ECE/TRANS/WP.29/GRRF/2009/11
25 November 2008

REGULATIONS Nos. 13 AND 13-H (Braking)

Trailer parking brake

Proposal for an amendment to Regulation No. 13

Figure 1

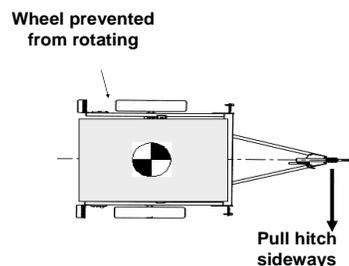
8.1.2. Prevent one of the wheels from rotating to ensure that the brakes on only one side of the trailer are forced to operate in the reverse direction (see figure 1 below).

Following this test, the parking brake should be released and the brakes re-settled prior to repeating the test on the wheel(s) on the other side of the axle(s) with the test layout requirements reversed.

8.1.3. Any resistance from the jockey wheel shall be removed as far as is practicable and the minimum load as calculated in paragraph 8.4. is applied at 90⁰ to the tow-hitch in the direction opposite from the side of the trailer to where the wheel(s) are prevented from rotating.

Figure 2: Calculation of relationship between applied side load and brake force

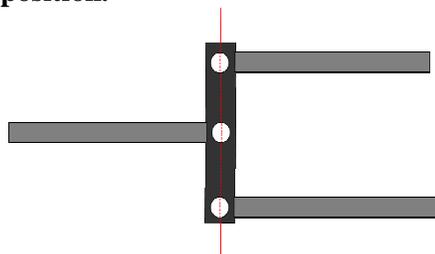
8.1.5.1. Calculate the minimum gradient force F_{app} required at the tow hitch to guarantee adequate performance from each brake.

Figure 2 below shows dimension x (the trailer track) and dimension y (the distance from the tow-hitch to the axle centre line).

8.1.5.2. The minimum total brake force F_{tb} (in Newton) to hold the trailer on an 18 per cent slope is defined by the following equation.

For the purposes of this test, it is assumed that 50 per cent of this force should be provided by each brake. The minimum applied force (F_{app}) that has to be resisted by the trailer brake is defined by the following formula:

$$F_{app} = \frac{x \cdot F_{tb}}{2 \cdot y}$$

All compensator pivots to be in-line

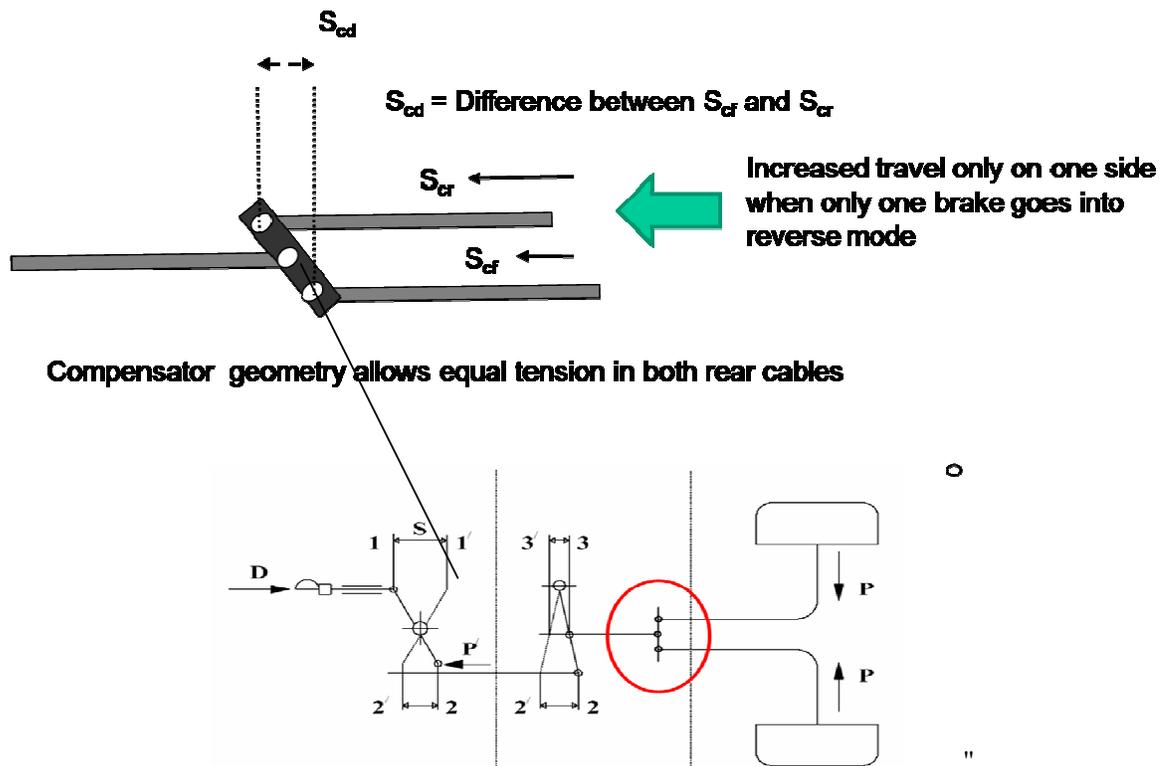
8.2.1. The pivot points in the compensator shall lie in a straight line with the park brake at the rest position.

Alternative arrangements can be used, if they provide equal tension in both rear cables, even when there are differences in travel between the rear cables.

8.2.2. Drawing details are to be provided to demonstrate that the compensator articulation is sufficient to ensure equal cable tension is applied to each of the rear cables. The compensator needs to have sufficient distance across the width to facilitate the differential travels left to right. The jaws of the yolks also need to be deep enough relative to their width to make sure that they do not prevent articulation when the compensator is at an angle.

Differential travel at compensator (s_{cd}) shall be derived from:

$$s_{cd} \geq 1.2 \cdot (S_{cr} - S_c')$$

Figure 2: Compensator operation

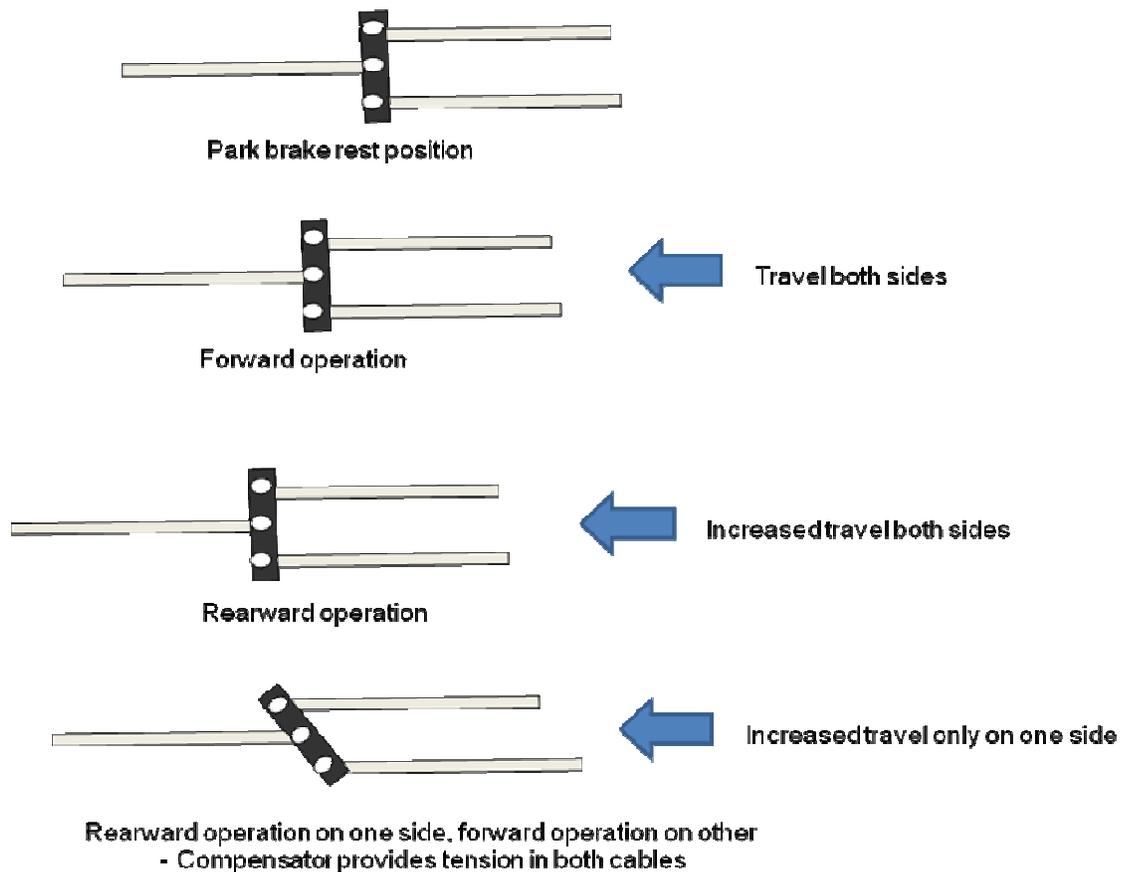
If the compensator design includes appropriate geometry, then both cables are subject to the same tension. Figure 2 shows the park brake operation of the compensator under various situations.

When the park brake is applied, the compensator applies tension to both rear cables. The compensator normally operates with either both brakes working in the forward or both in the reverse direction. However, if one wheel is stopped from moving by an external force (e.g. held against the kerb), then one brake can remain in the forward operating direction and the other will move into the reverse mode. This results in different travels in the left and right cables. The compensator must tilt to ensure that both cables are still held under the appropriate tension. This is shown in the last diagram in Figure 2.
